RESPONSE TO COUNCIL'S RFI 21 NOVEMBER 2023
CHROME TEMPLE GARAGE MONA VALE, 69 BASSETT STREET MONA VALE – DA2023/1068
29 NOVEMBER 2023

Image 1 – Plan

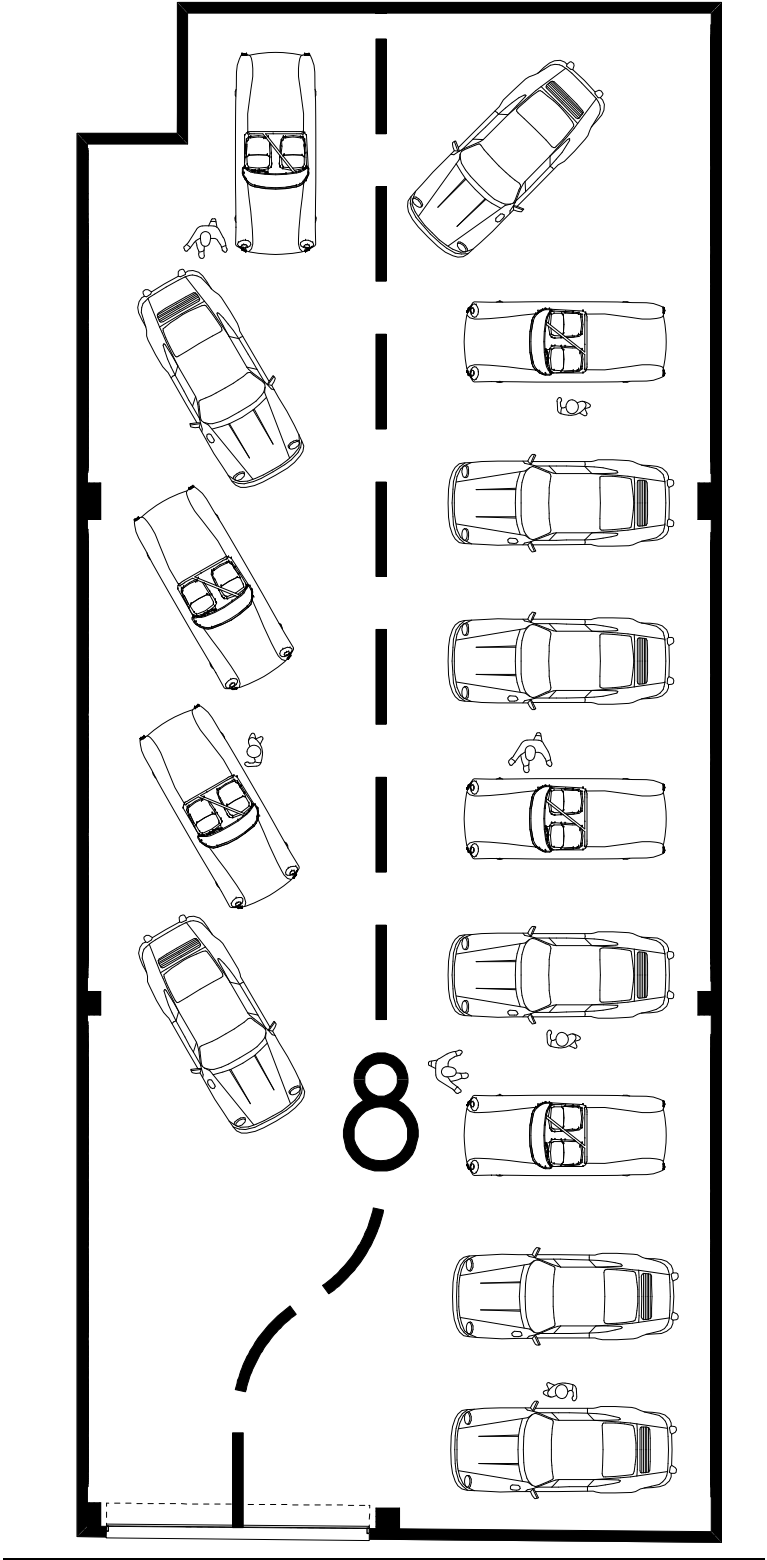
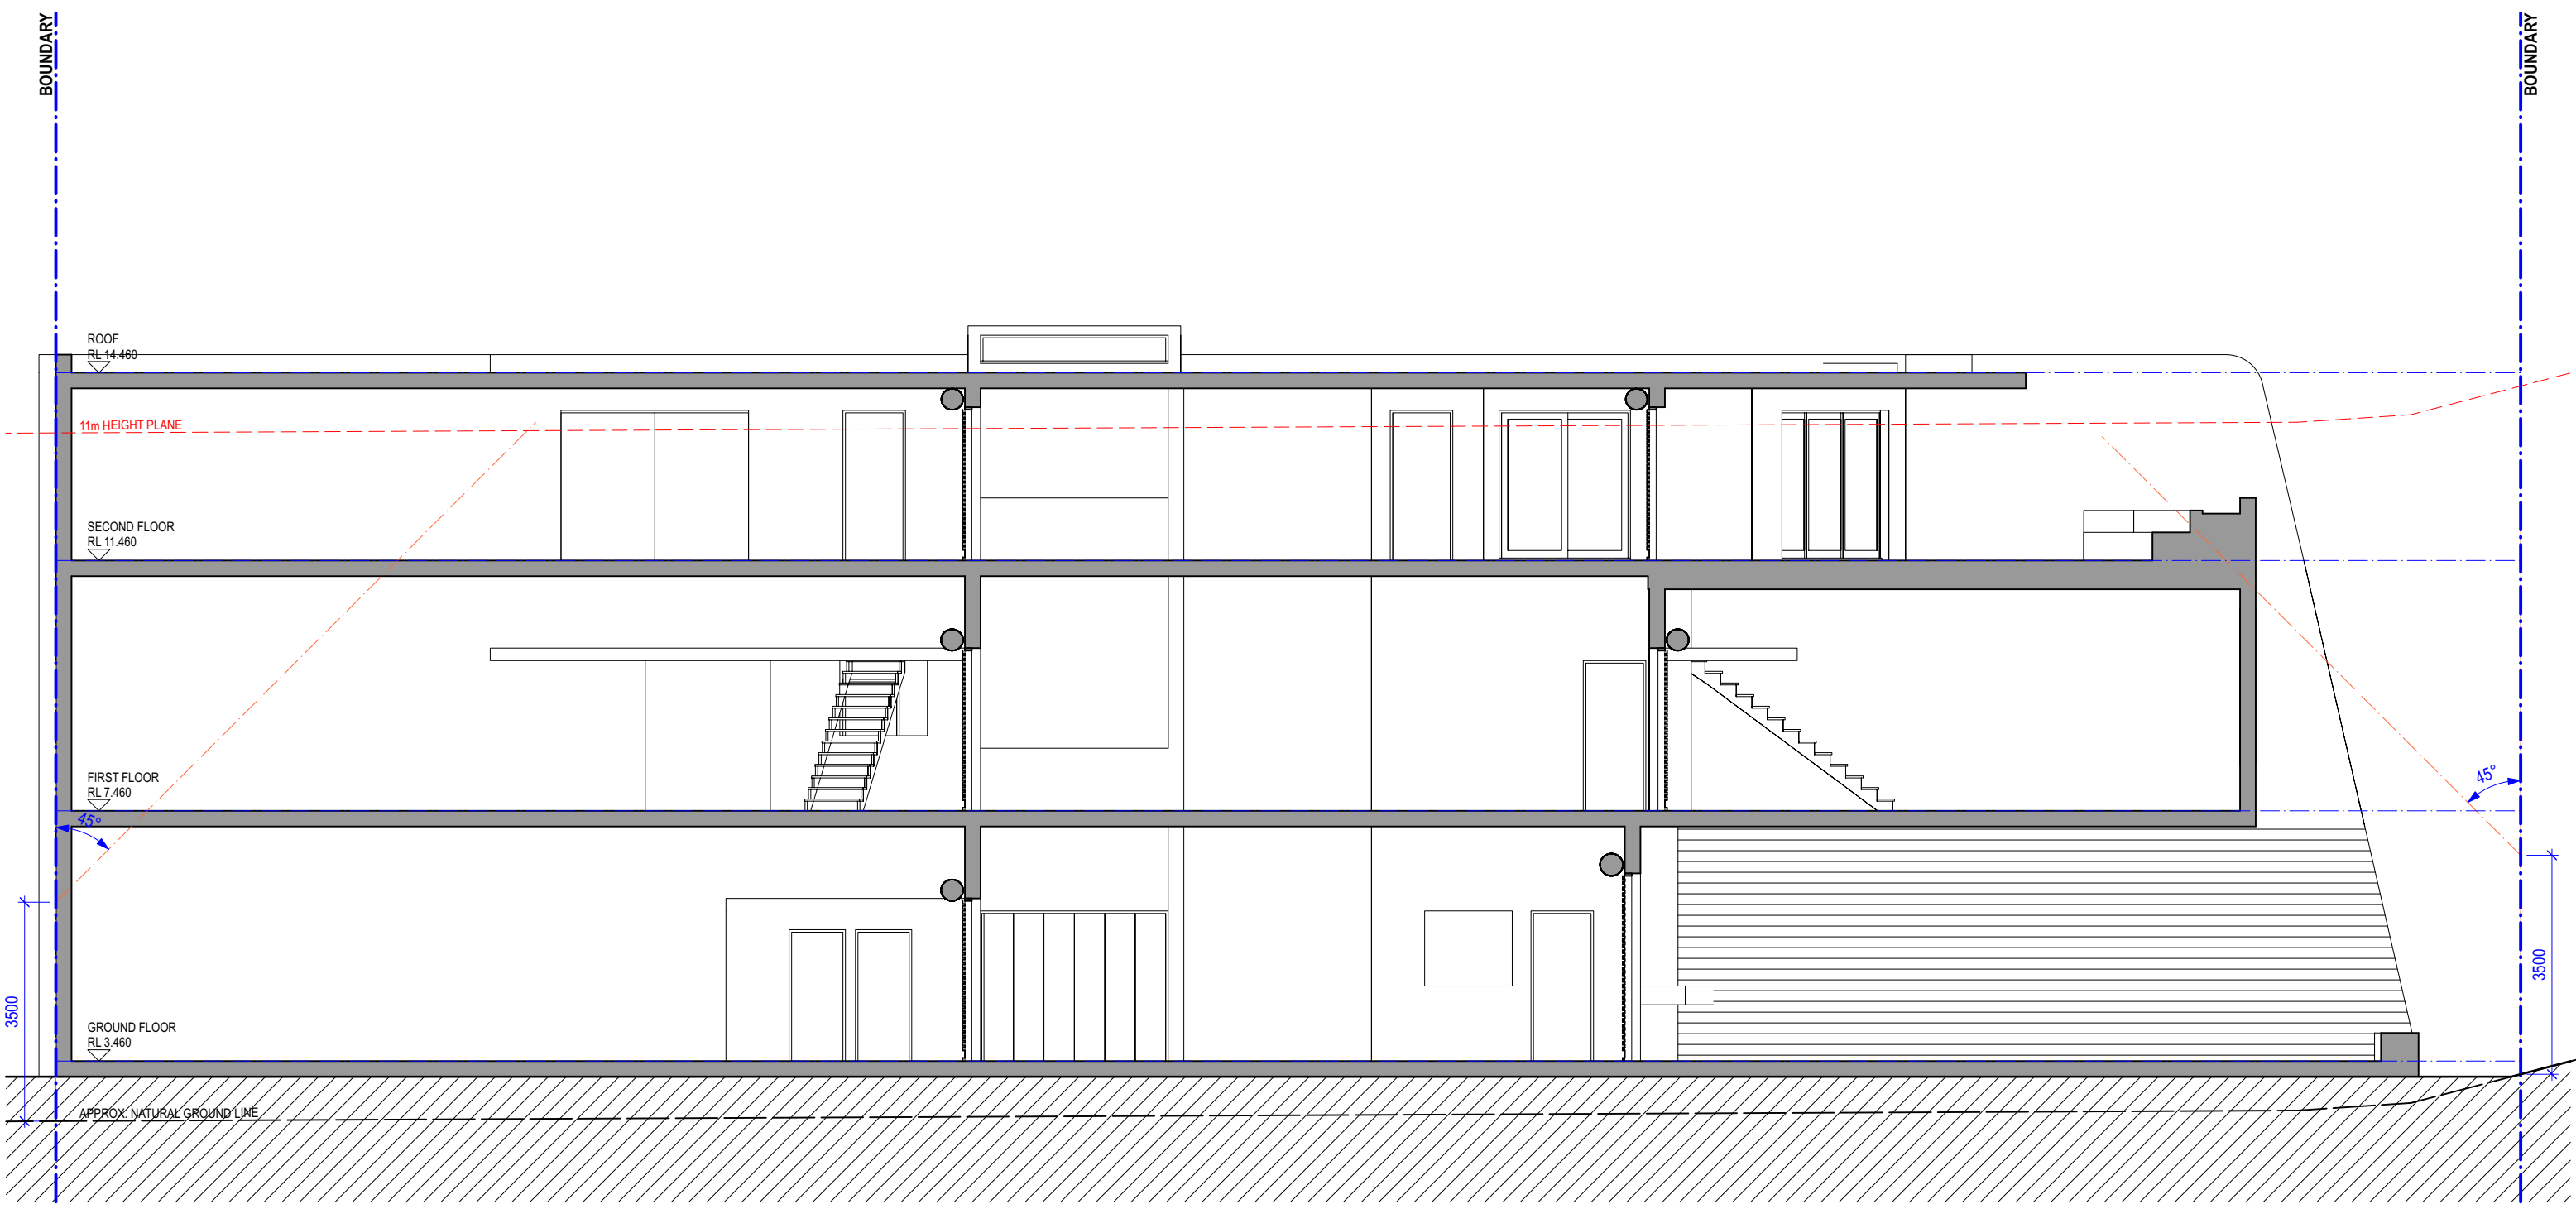
The request for analysis from survey data for similar developments is clearly not possible as this building type and use is a new concept.

The model (and idea for) for this development is based on a Unit developed in Brookvale for a prior client

(image attached).

This is a standard industrial unit used to store a private car collection.

The Owner visits the facility usually weekly or fortnightly and swaps over cars. This allows the cars to be run occasionally (low mileage is critical to the value of most vehicles).

SECTION

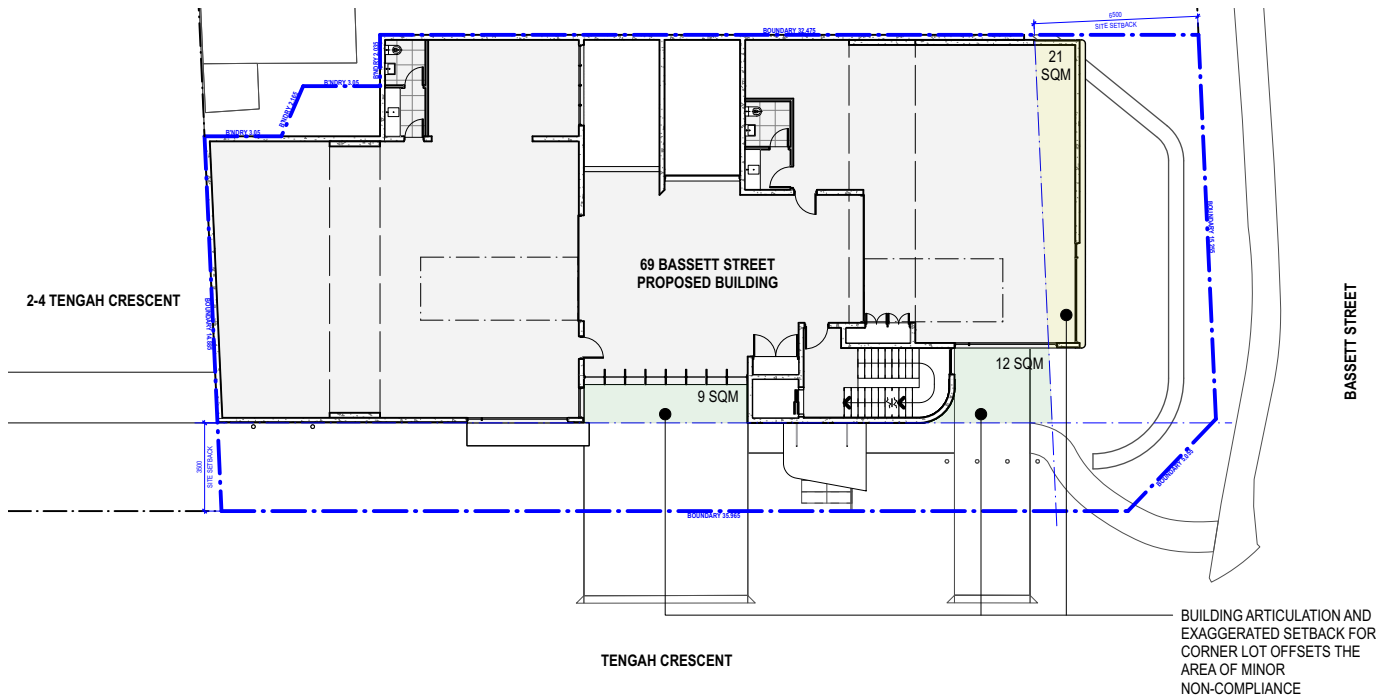
ISSUE 1 4.3 HEIGHT OF BUILDINGS

The Pre-DA submission showed a roof level of 14.46.

(copy of Pre-DA Section submitted attached)

- Roof level lowered to 14.460 to match Pre-DA.
The 2 raised elements, the clerestory light which provides natural light and ventilation to the internals of the building and the entry feature which provides articulation and graphic interest celebrating the street corner have been lowered from 16.56 to 16.160.

PLAN SHOWING SETBACK ARTICULATION

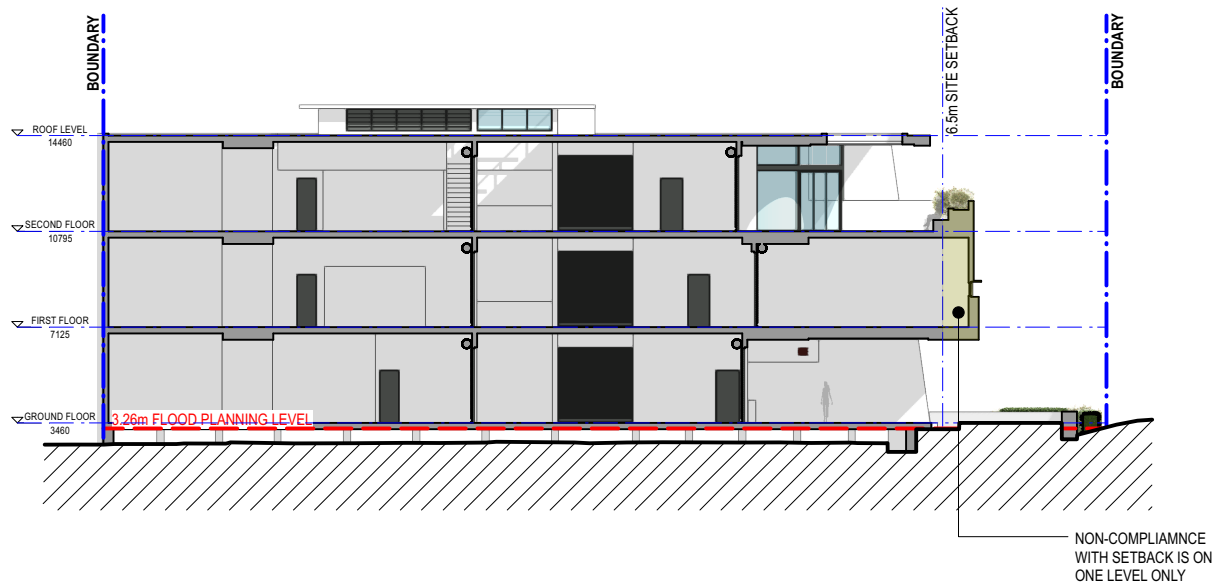
ISSUE 3 9.6 FRONT BUILDING LINE

The extent of encroachment into the setback is identical to the proposal at Pre-DA which was supported by Council because of the articulation particularly of the top floor. What was requested by Council at the Pre-DA was that the landscape be extended to the 6.5m line at the ground floor which was done.

At the ground floor the blade element to the west has been set back behind the setback line.

On the upper level the roof has been set back behind the building line.

The result is that only one level is within the setback, the built form on ground and second floor are well set back. The front setback for the middle level has a large setback on the corner approximately balancing the non compliance (see attached plan and section diagrams). This articulation allows a good streetscape outcome by reducing the bulk on the corner. It should also be noted that the setback is greater than existing and that this setback has not been consistently applied to recent projects on Bassett Street.
